Updated Firmware (H-6314_PTZ) for SN683D-WIR Camera

Camera	Older Firmware	Newest Firmware
SN683D-WIR	H-6314_PTZ_v2.3.9	H-6314_PTZ_v2.6.5

Privacy masks

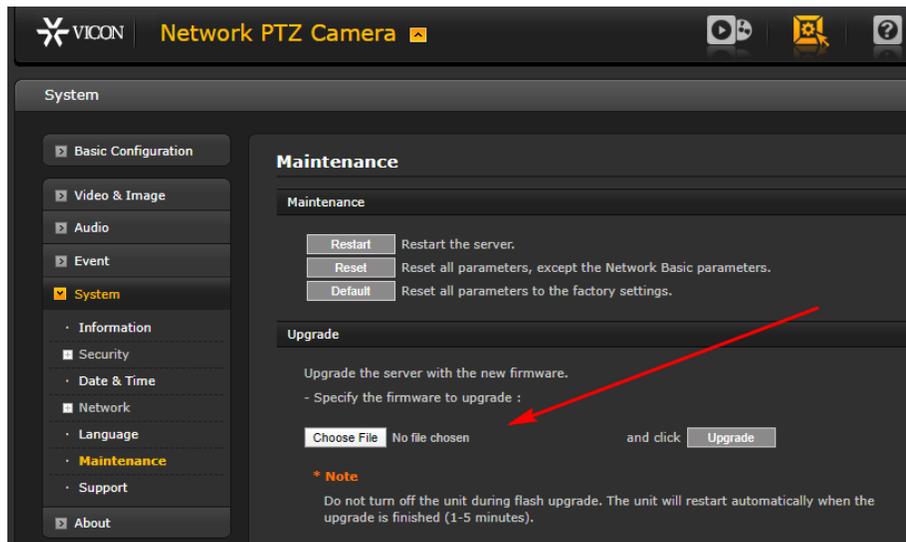
An issue was fixed where it was possible to configure privacy masks, even when it was disabled.
